Service Bulletin

Document: SB197

Title: Replacing a Soft-Start

Applies To: Replacing *Square-D™* or *GE QS2 series* With an *ABB™* Soft-Start

Figure 2: Control Power Wiring Diagram

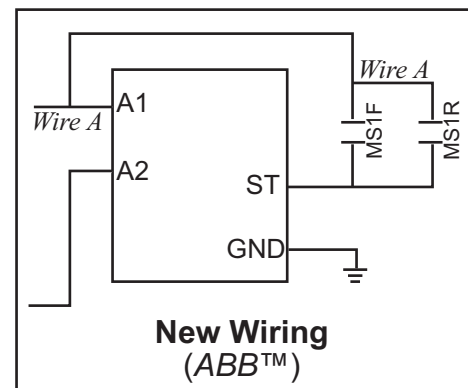
Old Terminals		CONTROL Power	
GE #	Square D #	Wire # <i>(write in)</i>	New Terminal #
A1	6		A1
A2	7		A2
2	3		See Figure 2
57	1		ST
	0		GND

Figure 3: Adjusting the Soft-Start

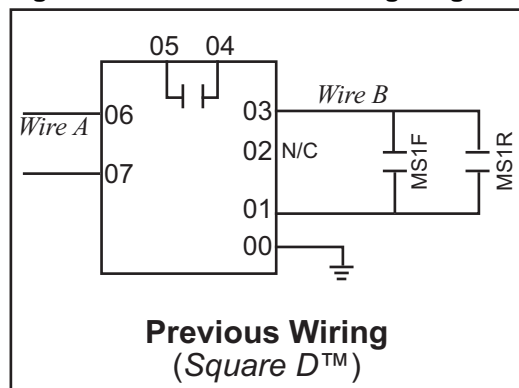
8. Screw the replacement soft-start in place.
9. Connect the wiring as indicated in Table 2 and Table 3 on page 6.
10. Adjust the potentiometer switches as they are shown in Figure 3 on page 7.

Startup Time in Seconds
Range: 1-20 seconds

Stop Time in Seconds
(including step down voltage)
Range: 0-20 seconds
2% reduction occurs for each second stop ramp is increased.
Ex: Stop ramp = 10 sec
10 sec x 2% = 80% step down
(20% reduction)

Step Down Percentage
Signifies the initial voltage percentage that the ramping of the start cycle begins with. The percentage allows the voltage to start the machine at a lower than line voltage and ramps up for a smooth transition. (The soft-stop mode is not used.)
